**UIC-CL1-008**

**RE: 2011 ANNUAL MIT ON INJECTION WELLS**

**From:** Chavez, Carl J, EMNRD  
**Sent:** Thursday, October 06, 2011 7:14 AM  
**To:** Chavez, Carl J, EMNRD  
**Subject:** Navajo Refining Company (UICI-008) WDWs 1, 2 & 3 MIT Meeting Determination on October 5, 2011

## Calibration Certificate

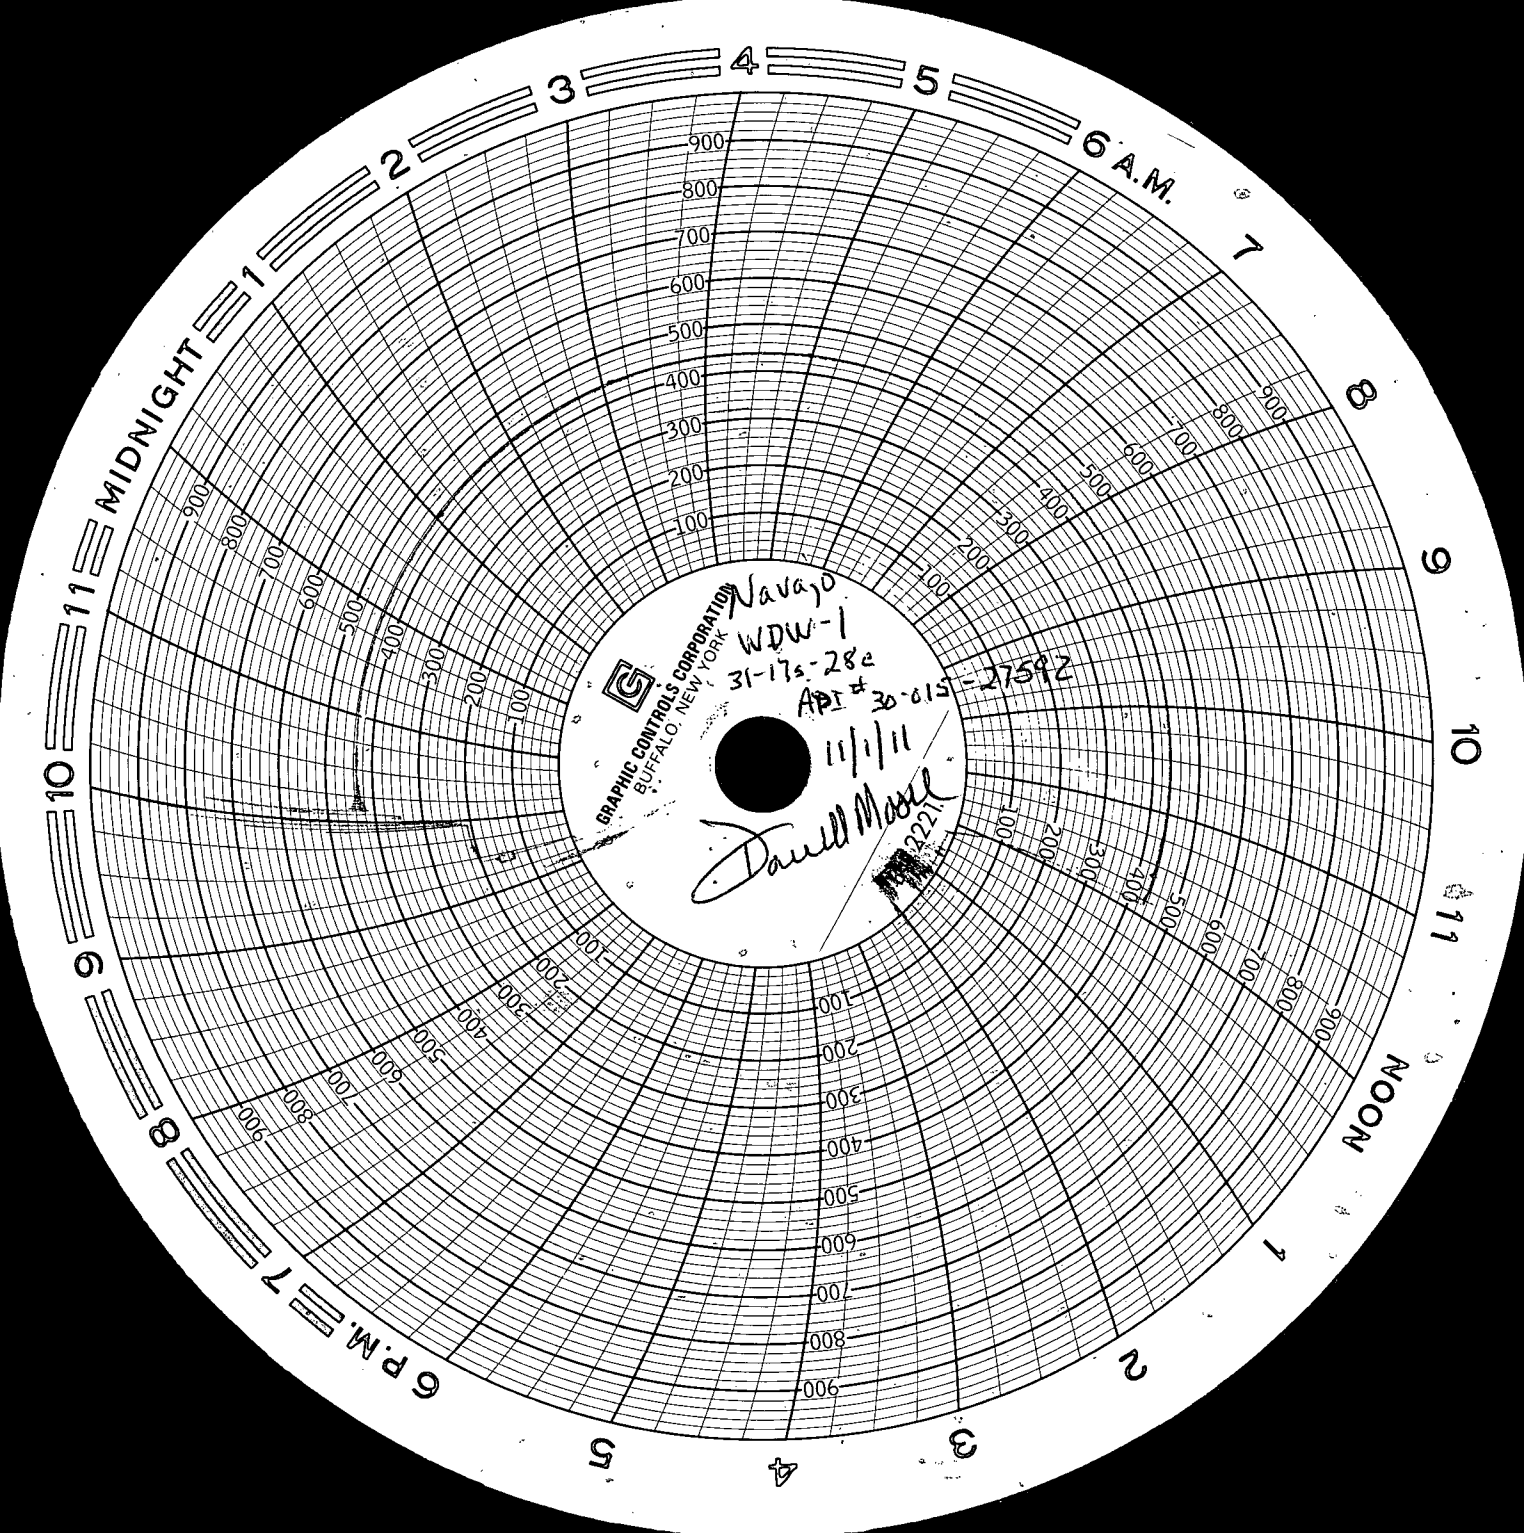
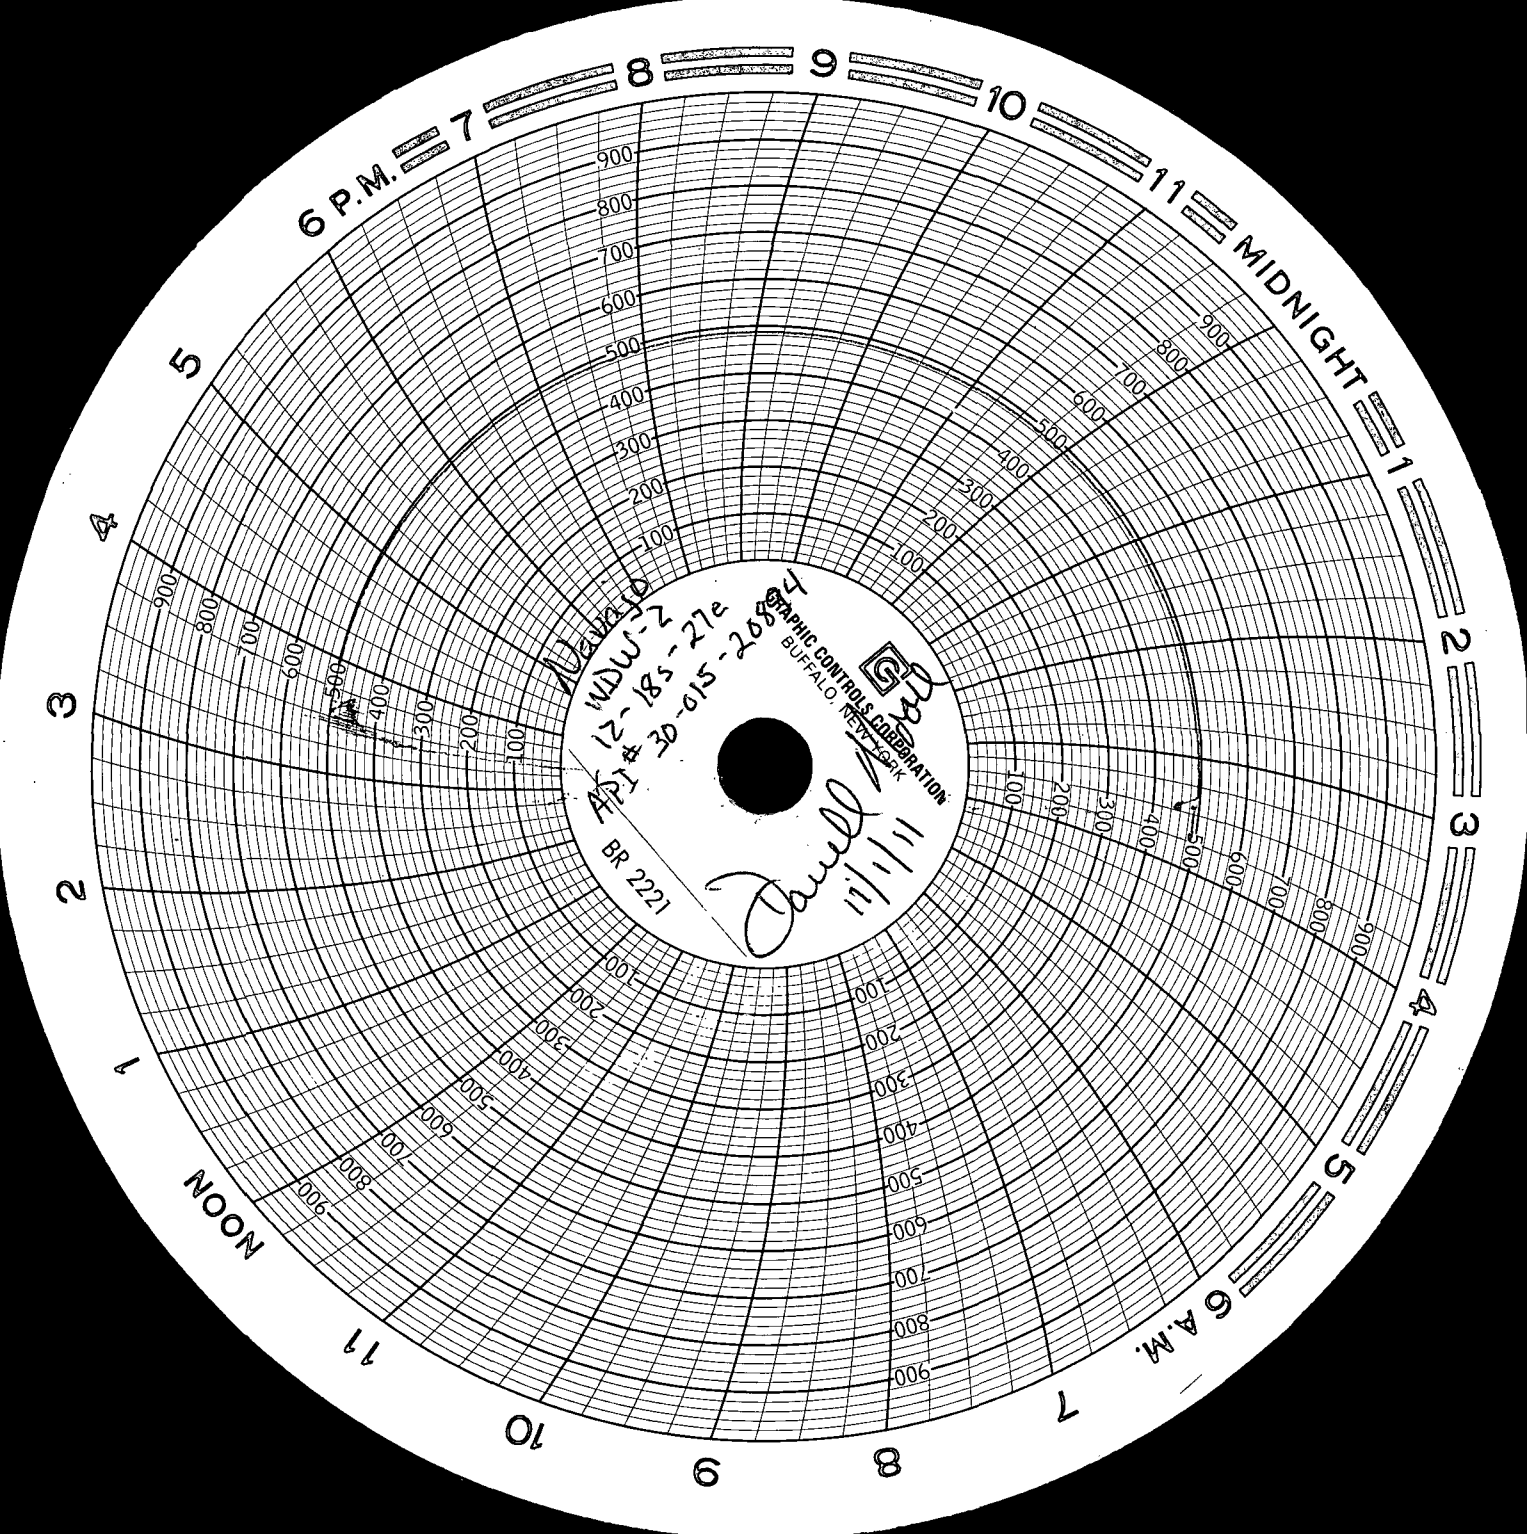
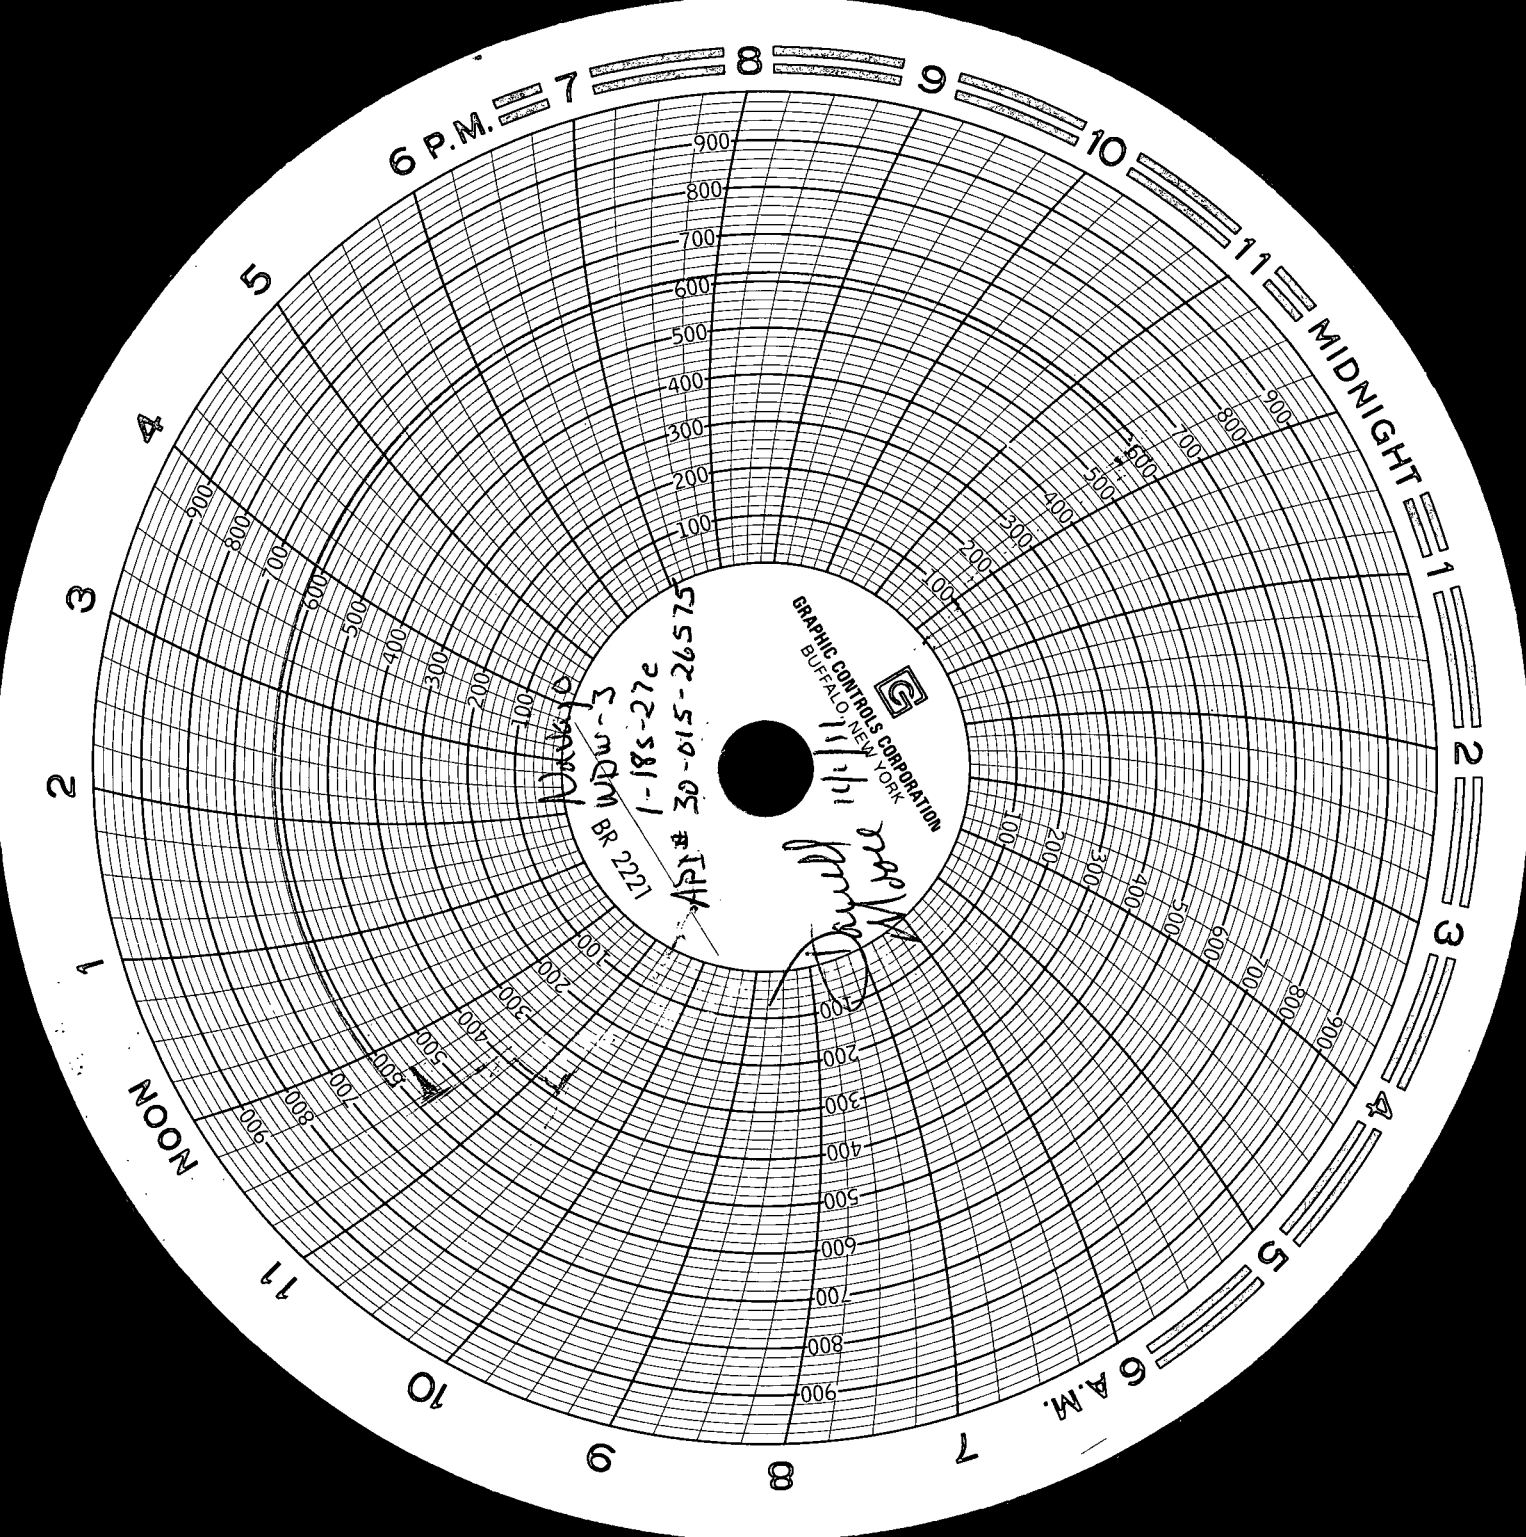
The charts indicate that the MITs passed for all injection wells. However, the OCD notices that the calibration sheet with date indicates that the chart recorder used for the well testing was last calibrated on January 19, 2011, which is greater than a 6-month period. In the future, please make sure that the chart recorder(s) used for all MITs are calibrated (and pass) within 6 months of the MIT date.
